## 3 COMMENTS AND RESPONSES

### 3.3 COMMUNITY GROUPS, PRIVATE COMPANIES, AND PRIVATE ORGANIZATIONS

To: Riverside Transmission Reliability Project

Subject: Property Affected by Riverside Transmission Reliability Project.

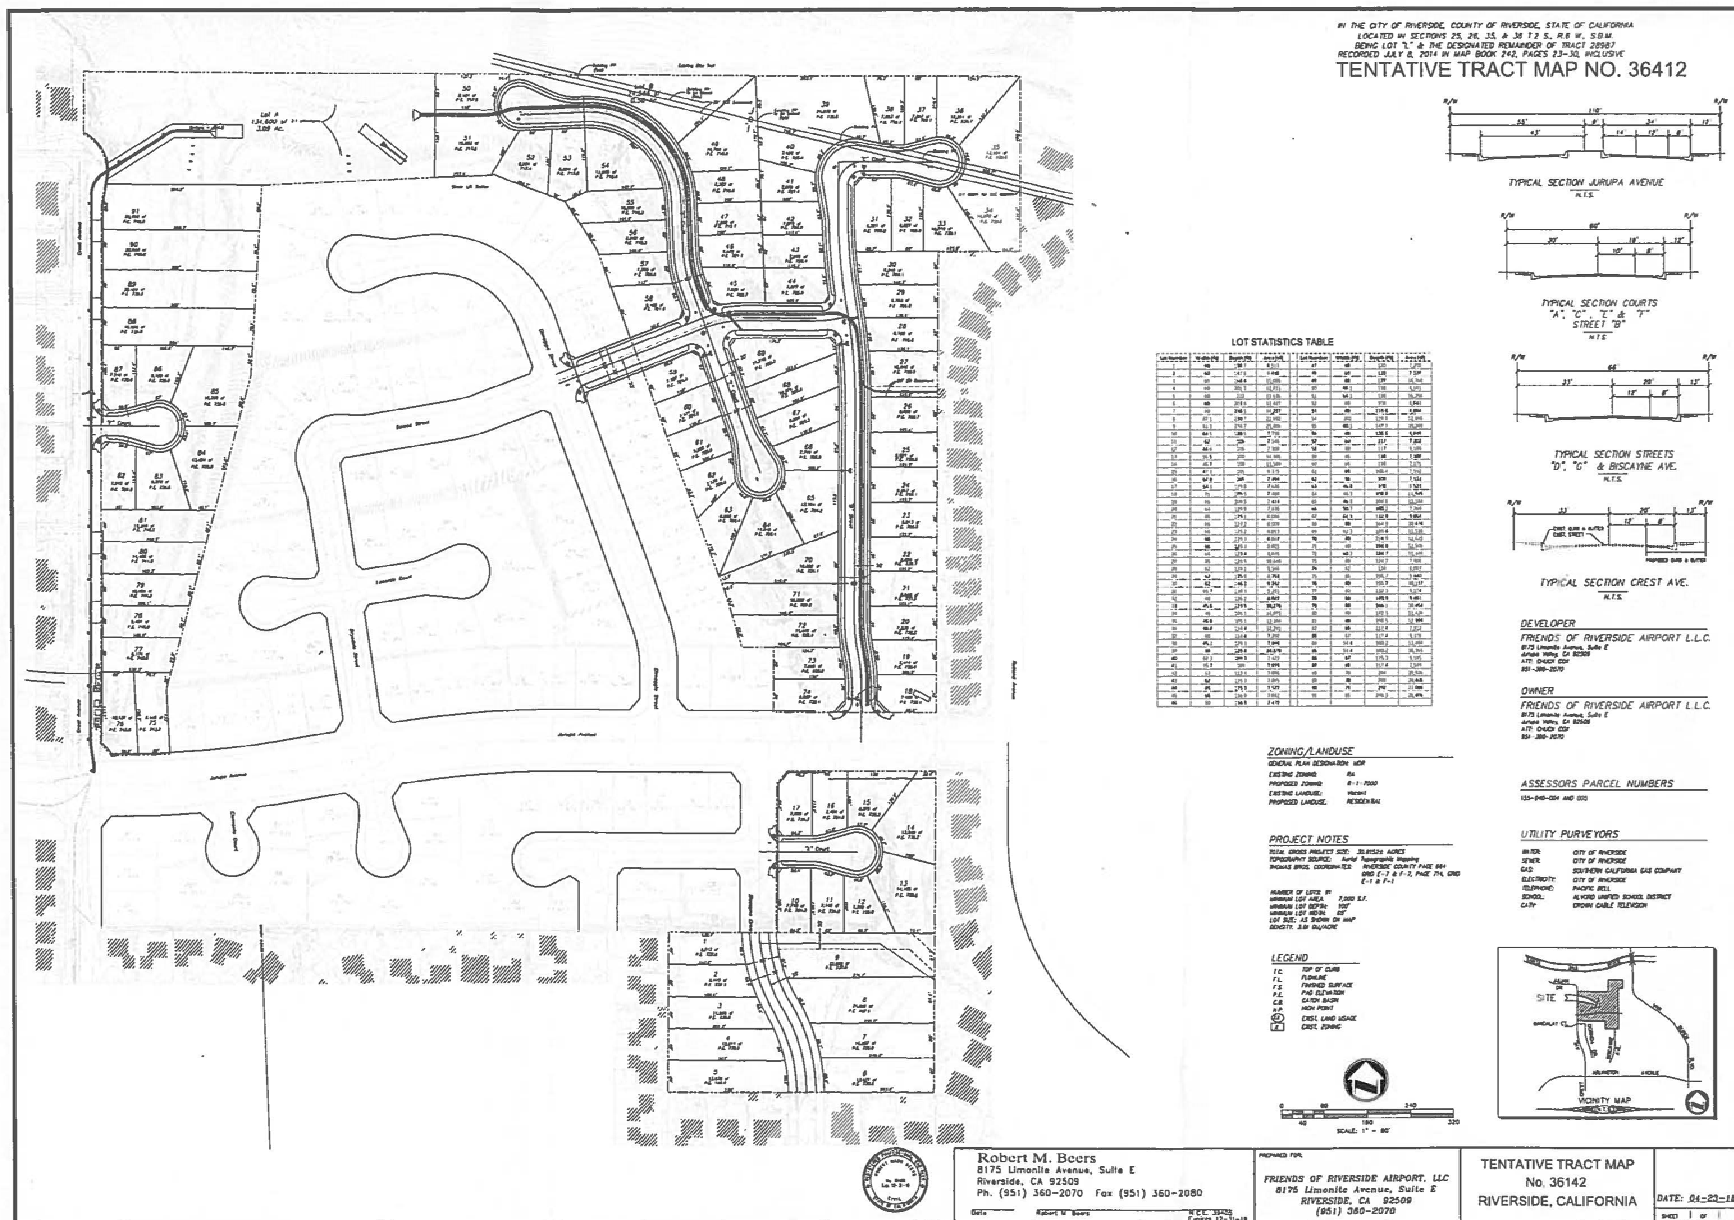
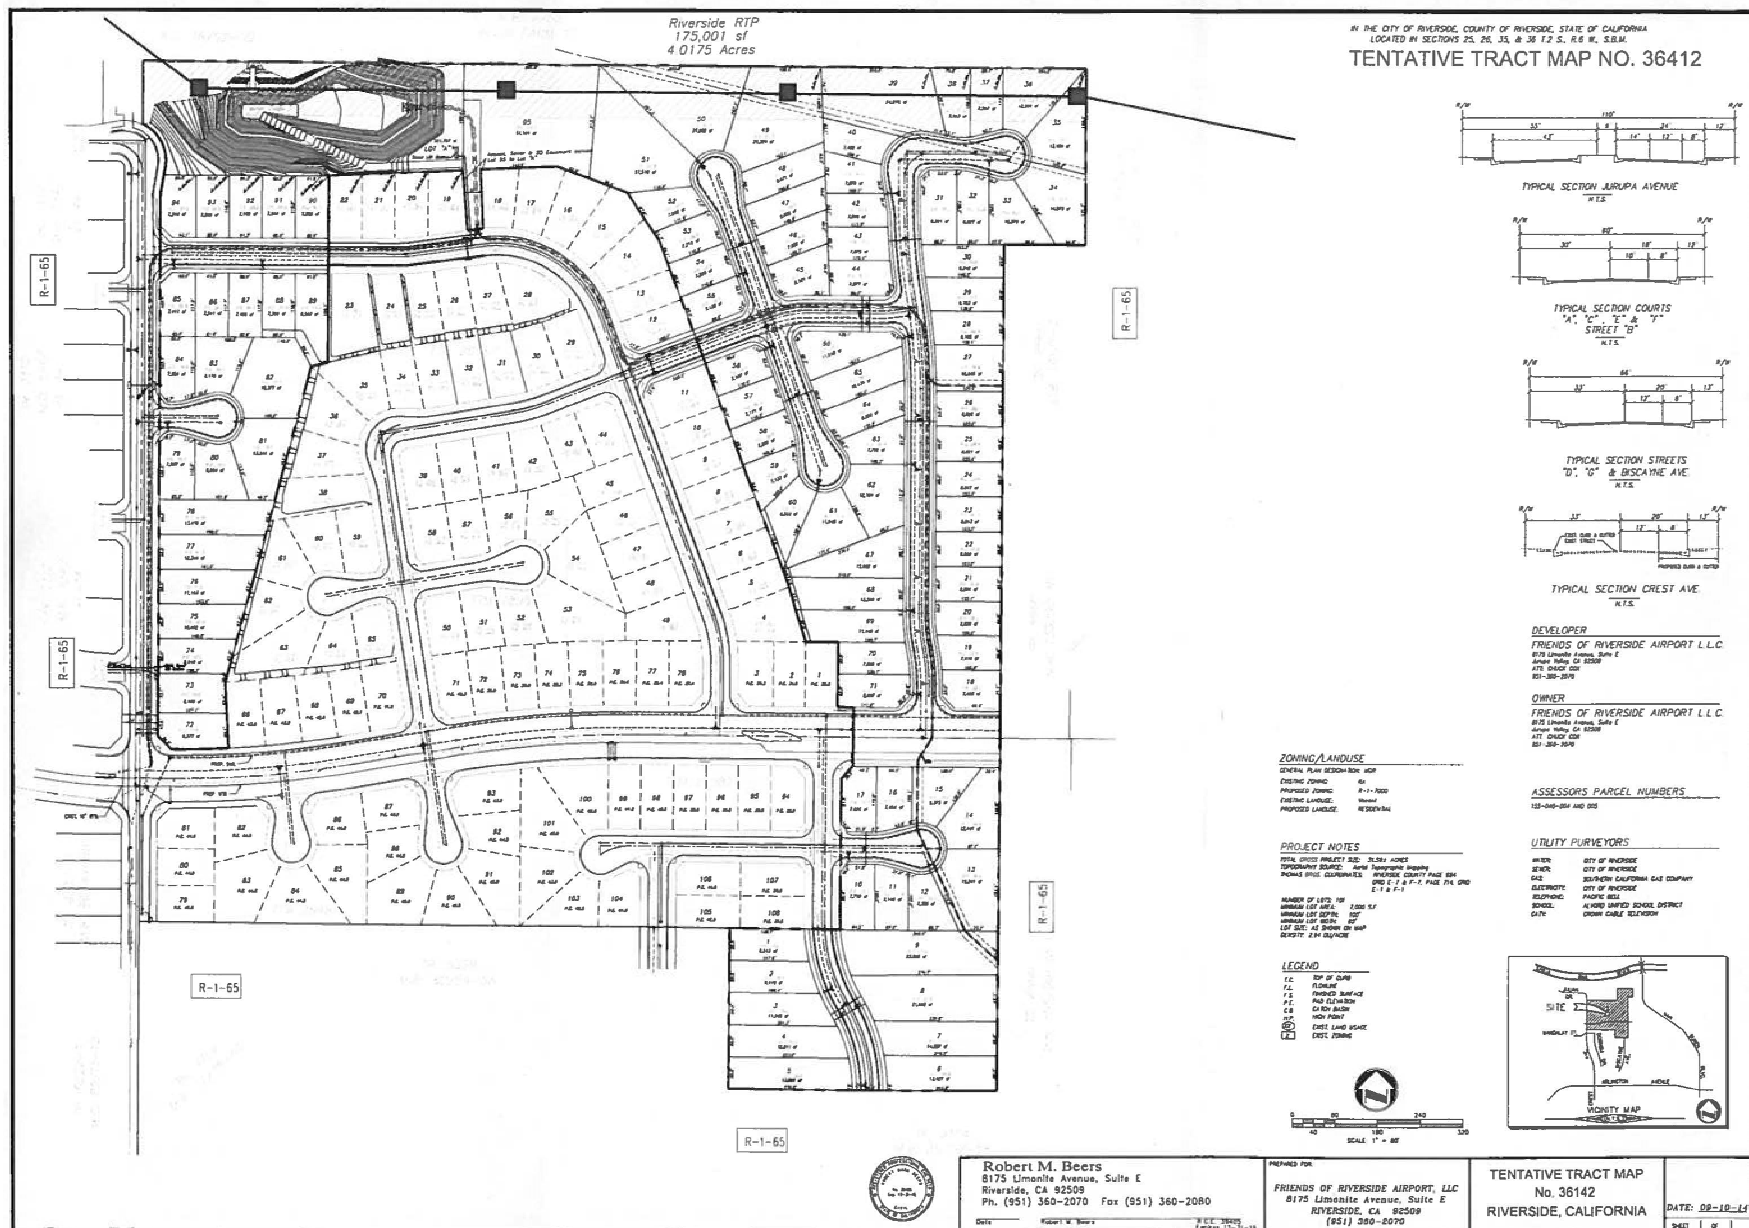
Attached please find a map showing our intended use for our property. We have been removing PCB's from the property under the supervision of the Department of Toxic Substances (DTSC). The City of Riverside has not allowed us to submit the attached map until the property meets the DTSC requirements. The project is covered by a Development Agreement between our LLC and the City.

The proposed taking for the power line would eliminate as many as 15 lots from the proposed map and would compromise the desirability of many more. Our clean up costs related to PCB's is approximately 30 million dollars for the 60 acres involved or an average of about \$500,000 per acre.

B1-1

B1-1 This comment refers to a segment of the Proposed Project transmission line south of the Santa Ana River. Impacts associated with the transmission line south of the Santa Ana River are analyzed in the certified 2013 RTRP EIR. The CPUC analyzed the physical environmental impacts associated with the Revised Project. The transmission line south of the river is not within the scope of the Subsequent EIR (refer to MR-3). The CPUC will consider the certified 2013 RTRP EIR for analysis of the Proposed Project elements that have not changed since certification of the EIR in 2013. Refer to MR-2 for more information on the adequacy of the certified 2013 RTRP EIR.

Financial compensation for cleanup of hazardous materials is not an impact considered by CEQA. The issue of compensation may be raised within the CPUC General Proceeding. For information on participation in CPUC proceedings, refer to MR-4.

**Figure 1: RPU's Peak Load Projections and Its Current Load Serving Capability**

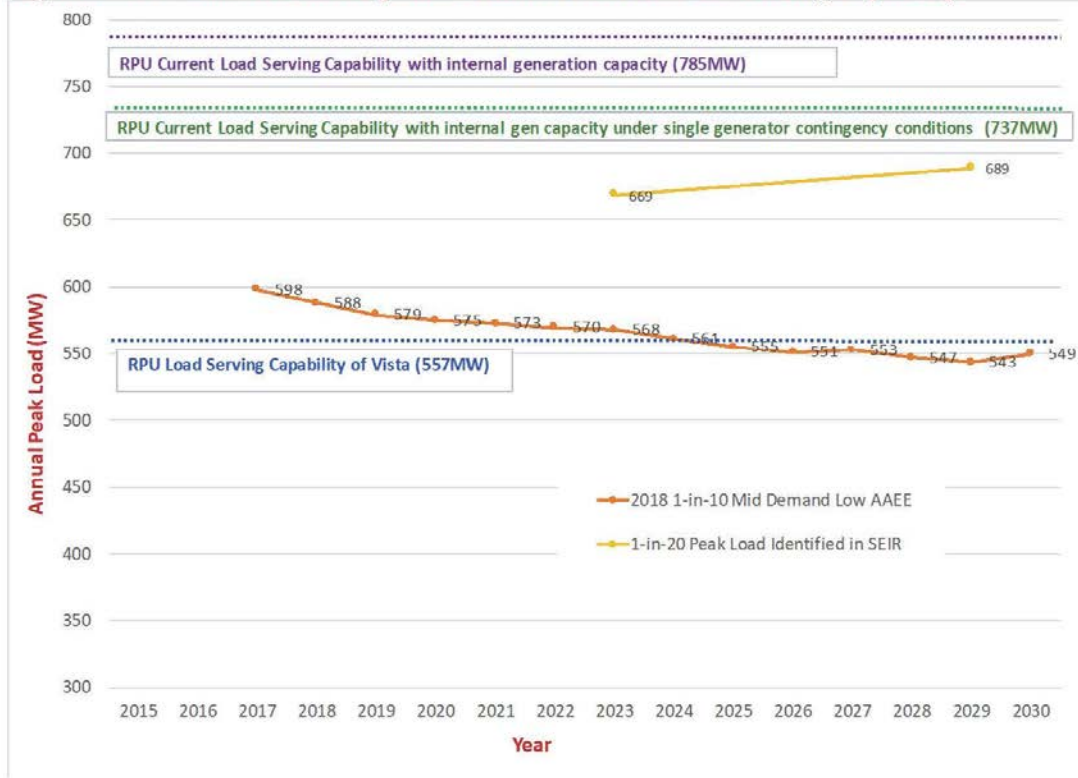
Integrated Energy Policy Report (IEPR), indicates that the RPU loads are declining through 2030 further reducing the need for increasing system capacity to meet RPU's demand needs.

B7-2

This load data indicates that there is no need whatsoever to increase capacity to meet RPU's existing electrical system demand and anticipated future load growth over the 10-year planning horizon.

- B7-3      As stated in the response B7-2, the objectives for the project were defined in compliance with CEQA Guidelines. The need for the project will be addressed by
